ECE/TRANS/WP.29/GRE/2009/61  
14 July 2009

**REGULATION No. 37**  
**(Filament lamps)**

**Proposal for Supplement 35 to the 03 series of amendments to Regulation No. 37 \*/**

**Submitted by the expert from the Working Party "Brussels 1952"**

CATEGORIES P13W and PW13W

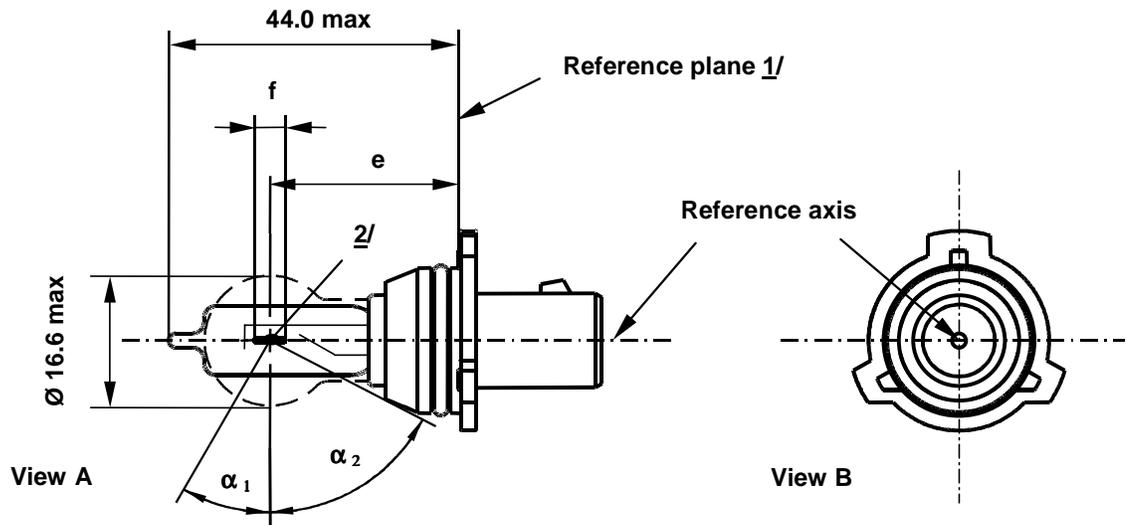
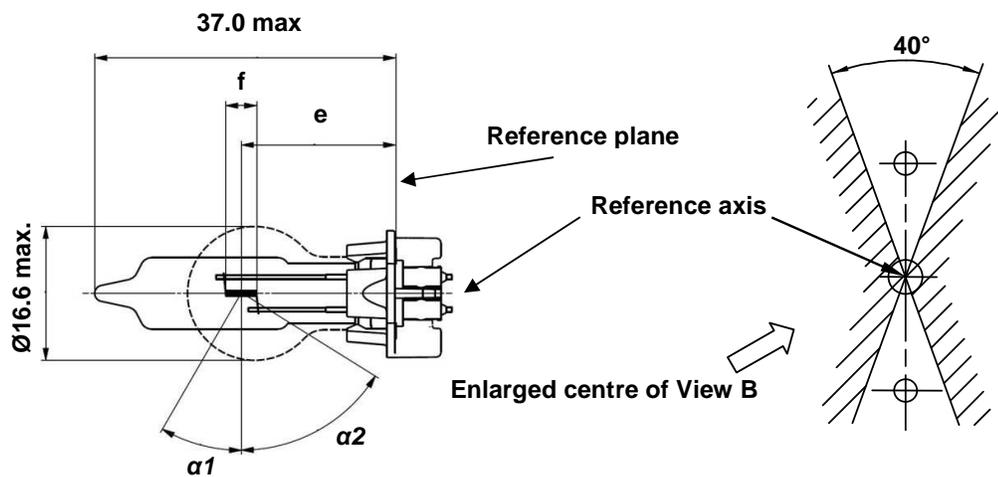
Sheets P13W/1 to P13W/3 (existing), replace by the new sheets P13W/1 to P13W/3, to read (see below):

Dimensions in mm		Filament lamps of normal production		Standard filament lamp	
e	<u>5/</u>	<b>P13W</b>	25.0	<u>4/</u>	25.0 ± 0.25
		<b>PW13W</b>	<b>19.25</b>	<u>4/</u>	<b>19.25 ± 0.25</b>
f	<u>5/</u>		4.3	<u>4/</u>	4.3 ± 0.25
$\alpha_1$	<u>6/</u>		30.0° min.		30.0° min.
$\alpha_2$	<u>6/</u>		58.0° min.		58.0° min.
P13W	Cap PG18.5d-1	in accordance with IEC Publication 60061 (sheet 7004-147-1)			
<b>PW13W</b>	<b>Cap WP3.3x14.5-7</b>	<b>in accordance with IEC Publication 60061 (sheet 7004-xxx-x)</b>			
ELECTRICAL AND PHOTOMETRIC CHARACTERISTICS					
Rated values	Voltage	V	12		12
	Wattage	W	13		13
Test voltage		V	13.5		13.5
Objective values	Wattage	W	19 max.		19 max.
	Luminous flux	lm	250		
		±	+15% / -20%		
Reference luminous flux at approximately 13.5V					250 lm

**CATEGORIES PC16W, PCY16W, PCR16W, PW16W, PWY16W and PWR16W**

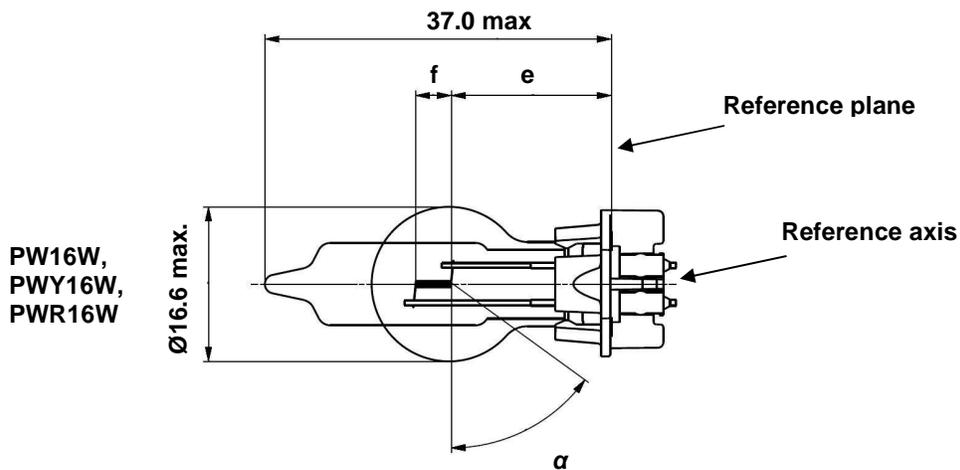
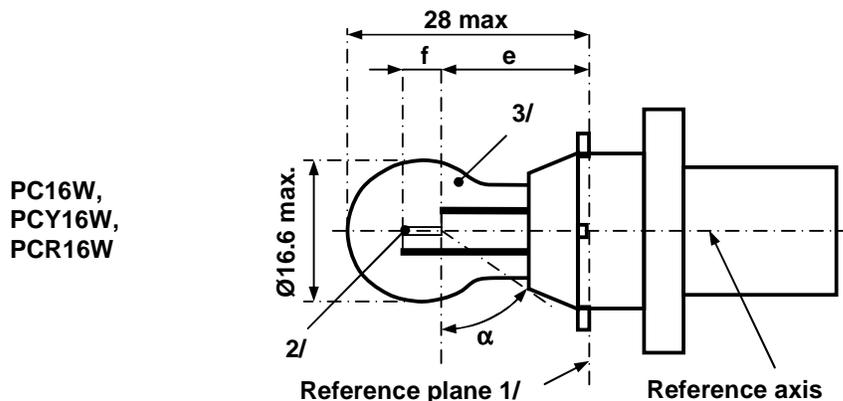
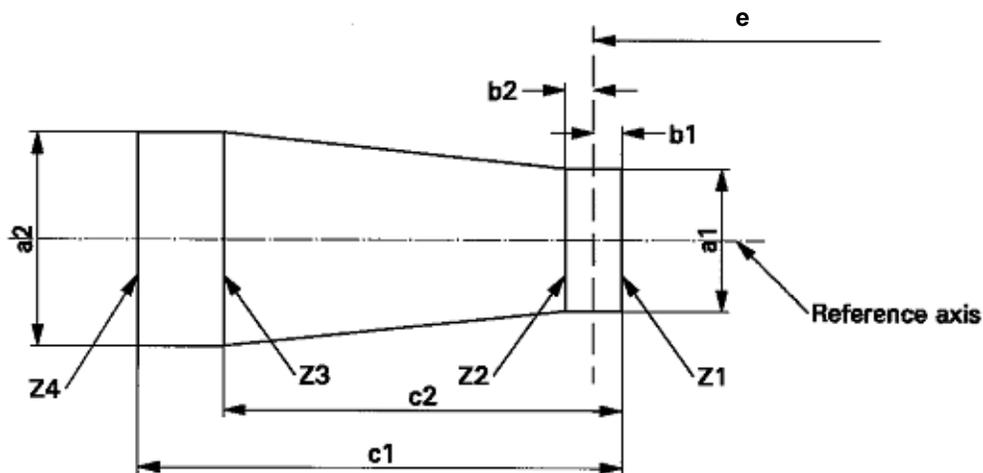
Sheets PC16W/1 to PC16W/3 (existing), replace by the new sheets PC16W/1 to PC16W/3, to read (see below):

Dimensions in mm		Filament lamps of normal production			Standard filament lamp
		min.	nom.	max.	<u>7/</u>
e	PC16W PCY16W PCR16W		18.5		18.5
	PW16W PWY16W PWR16W		<b>17.1</b>		<b>17.1</b>
f		<u>4/ 5/</u>	4.0		4.0 ± 0.2
α		<u>6/</u>	54°		54° min.
PC16W	Cap PU20d-1	in accordance with IEC Publication 60061 (sheet 7004-157-1)			
PCY16W	Cap PU20d-2				
PCR16W	Cap PU20d-7				
PW16W	Cap WP3.3x14.5-8	in accordance with IEC Publication 60061 (sheet 7004-XXX-X)			
PWY16W	Cap WP3.3x14.5-9				
PWR16W	Cap WP3.3x14.5-10				
ELECTRICAL AND PHOTOMETRIC CHARACTERISTICS					
Rated values	Volts		12		12
	Watts		16		16
Test voltage	Volts		13.5		13.5
Objective values	Watts		17 max.		17 max.
	Luminous flux	PC16W <b>PW16W</b>	300 ± 15 %		
		PCY16W <b>PWY16W</b>	180 ± 20 %		
		PCR16W <b>PWR16W</b>	70 ± 20 %		
Reference luminous flux at approximately			13.5 V		White: 300 lm Amber: 180 lm Red: 70 lm

<b>PW16W, PWY16W and PWR16W</b>	a1	a2	b1, b2	c1	c2
<b>Filament lamps of normal production</b>	<b>2.5</b>	<b>2.5</b>	<b>0.4</b>	<b>5.2</b>	<b>3.8</b>
<b>Standard filament lamps</b>	<b>1.5</b>	<b>1.7</b>	<b>0.25</b>	<b>4.7</b>	<b>3.8</b>

**CATEGORIES P19W, PY19W, PR19W, PS19W, PSY19W, PSR19W, PW19W, PWY19W and PWR19W**

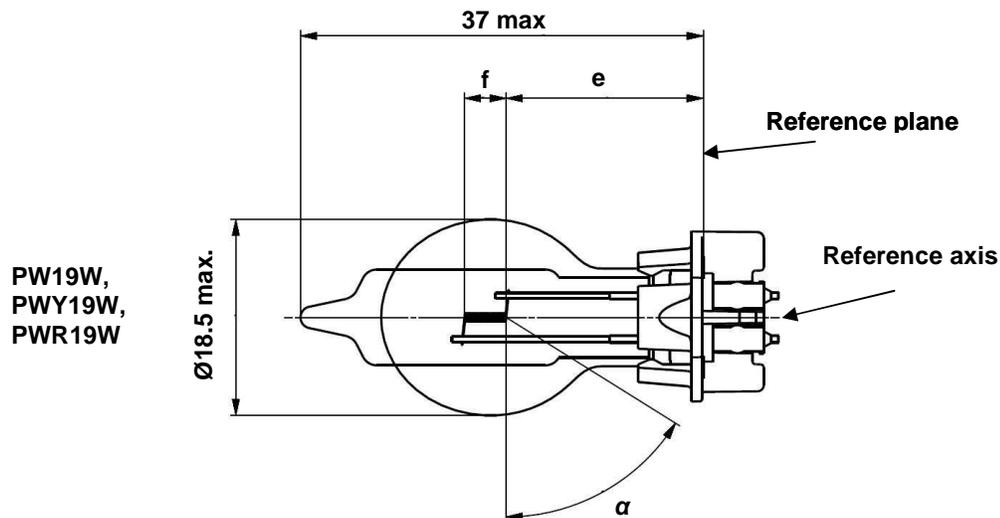
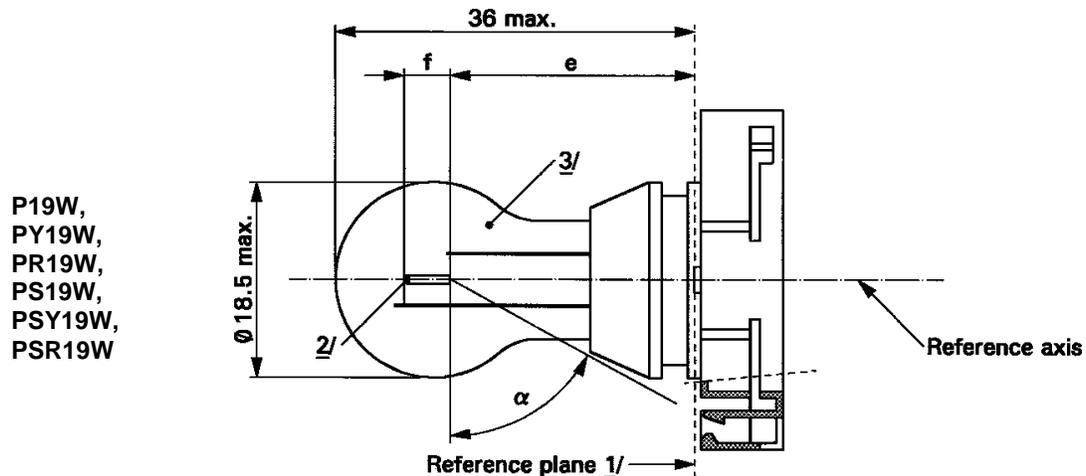
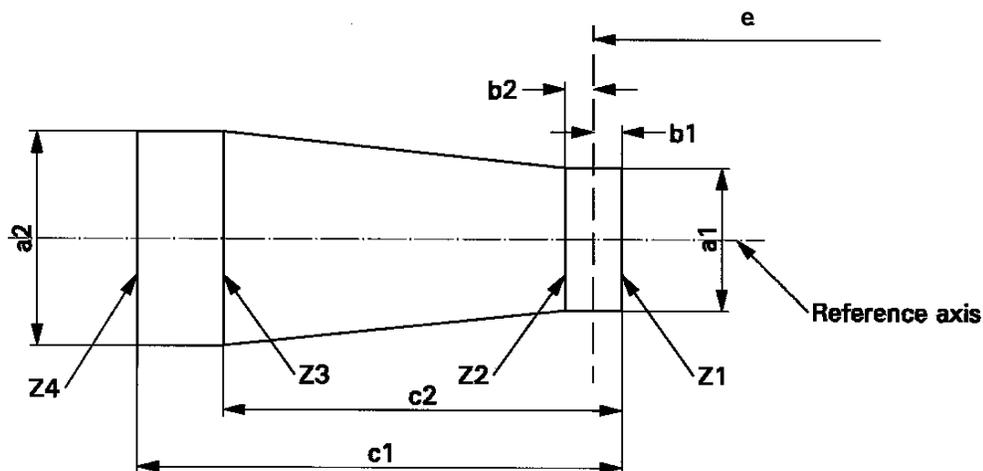
Sheets P19W/1 to P19W/3 (existing), replace by the new sheets P19W/1 to P19W/3, to read (see below):

Dimensions in mm		Filament lamps of normal production			Standard filament lamp	
		min.	nom.	max.	8/	
e	4/		24.0		24.0	
	5/ 6/		18.1		18.1	
f	5/ 6/		4.0		4.0 ± 0.2	
α	7/	58°			58° min.	
P19W	Cap PGU20-1	in accordance with IEC Publication 60061 (sheet 7004-127-2)				
PY19W	Cap PGU20-2					
PR19W	Cap PGU20-5					
PS19W	Cap PG20-1					
PSY19W	Cap PG20-2					
PSR19W	Cap PG20-5					
<b>PW19W</b>	<b>Cap WP3.3x14.5-1</b>	in accordance with IEC Publication 60061 (sheet 7004-xxx-x)				
<b>PWY19W</b>	<b>Cap WP3.3x14.5-2</b>					
<b>PWR19W</b>	<b>Cap WP3.3x14.5-5</b>					
ELECTRICAL AND PHOTOMETRIC CHARACTERISTICS						
Rated values	Volts	12			12	
	Watts	19			19	
Test voltage	Volts	13.5			13.5	
Objective values	Watts	20 max.			20 max.	
	Luminous flux	P19W PS19W <b>PW19W</b>	350 ± 15 %			
		PY19W PSY19W <b>PWY19W</b>	215 ± 20 %			
		PR19W PSR19W <b>PWR19W</b>	80 ± 20 %			
Reference luminous flux at approximately 13.5 V					White: 350 lm Amber: 215 lm Red: 80 lm

<b>PW19W, PWY19W and PWR19W</b>	<b>a1</b>	<b>a2</b>	<b>b1, b2</b>	<b>c1</b>	<b>c2</b>
<b>Filament lamps of normal production</b>	<b>2.5</b>	<b>2.5</b>	<b>0.4</b>	<b>5.2</b>	<b>3.8</b>
<b>Standard filament lamps</b>	<b>1.5</b>	<b>1.7</b>	<b>0.25</b>	<b>4.7</b>	<b>3.8</b>

**CATEGORIES P24W, PX24W, PY24W, PR24W, PS24W, PSX24W, PSY24W, PSR24W, PW24W, PWY24W and PWR24W**

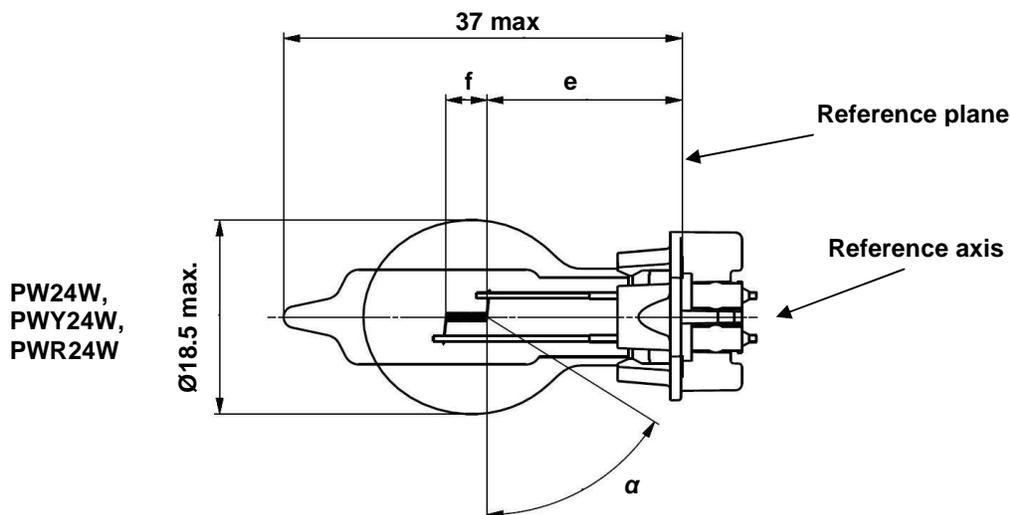
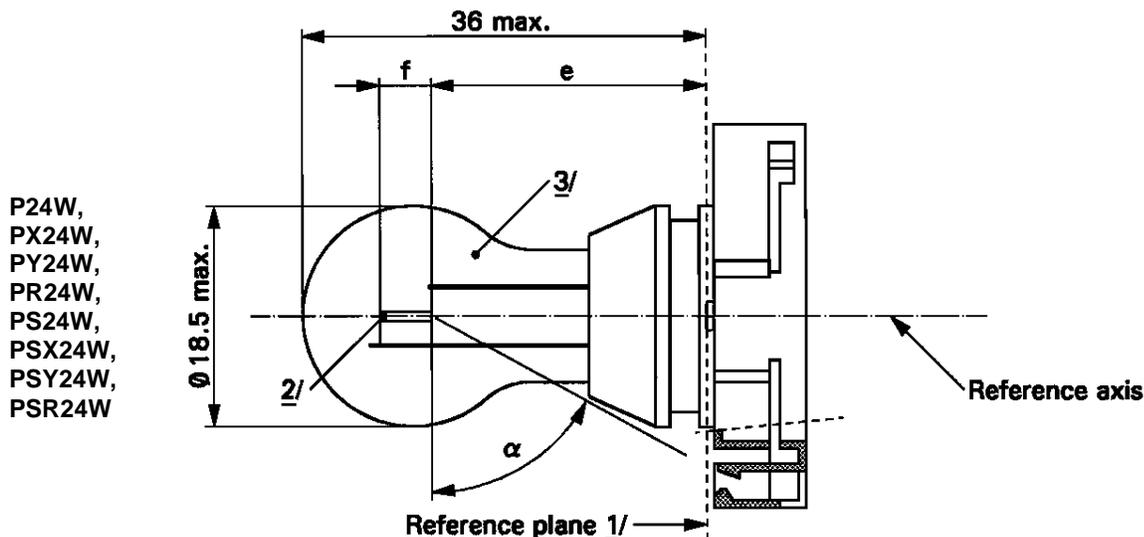
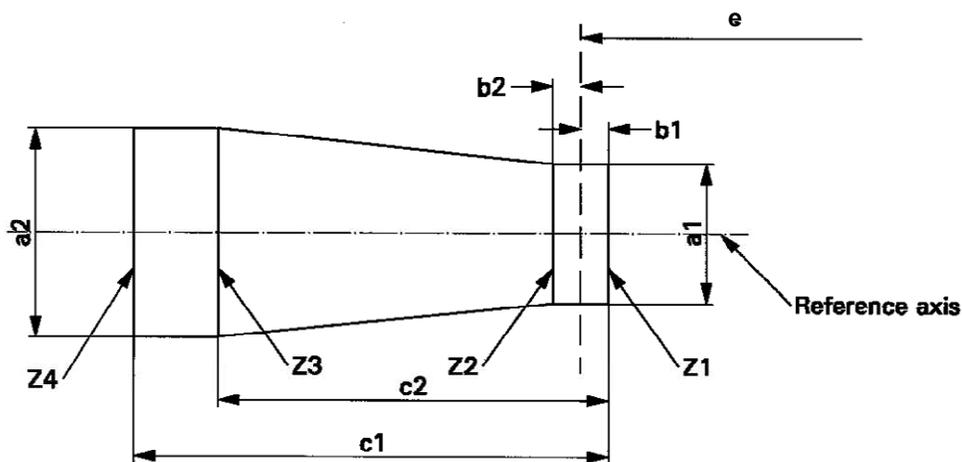
Sheets P24W/1 to P24W/3 (existing), replace by the new sheets P24W/1 to P24W/3, to read (see below):

Dimensions in mm		4/	Filament lamps of normal production			Standard filament lamp
			min.	nom.	max.	8/
e	5/ 6/	<b>P24W, PY24W, PR24W, PS24W, PSY24W, PSR24W, PX24W, PSX24W</b>		24.0		24.0
			<b>PW24W, PWY24W, PWR24W</b>		<b>18.1</b>	
f	5/,6/	<b>P24W, PY24W, PR24W, PS24W, PSY24W, PSR24W, PW24W, PWY24W, PWR24W</b>		4.0		4.0
			<b>PX24W, PSX24W</b>		4.2	
$\alpha$		7/	58.0 °			58.0° min.
P24W	Cap PGU20-3	in accordance with IEC Publication 60061 (sheet 7004-127-2)				
PX24W	Cap PGU20-7					
PY24W	Cap PGU20-4					
PR24W	Cap PGU20-6					
PS24W	Cap PG20-3					
PSX24W	Cap PG20-7					
PSY24W	Cap PG20-4					
PSR24W	Cap PG20-6					
<b>PW24W</b>	<b>Cap WP3.3x14.5-3</b>	in accordance with IEC Publication 60061 (sheet 7004-XXX-X)				
<b>PWY24W</b>	<b>Cap WP3.3x14.5-4</b>					
<b>PWR24W</b>	<b>Cap WP3.3x14.5-6</b>					
<b>ELECTRICAL AND PHOTOMETRIC CHARACTERISTICS</b>						
Rated values	Volts	12			12	
	Watts	24			24	
Test voltage	Volts	13.5			13.5

<b>PW24W, PWY24W, PWR24W</b>	<b>a1</b>	<b>a2</b>	<b>b1, b2</b>	<b>c1</b>	<b>c2</b>
<b>Filament lamps of normal production</b>	<b>2.5</b>	<b>2.5</b>	<b>0.4</b>	<b>5.0</b>	<b>3.8</b>
<b>Standard filament lamps</b>	<b>1.5</b>	<b>1.7</b>	<b>0.25</b>	<b>4.7</b>	<b>3.8</b>
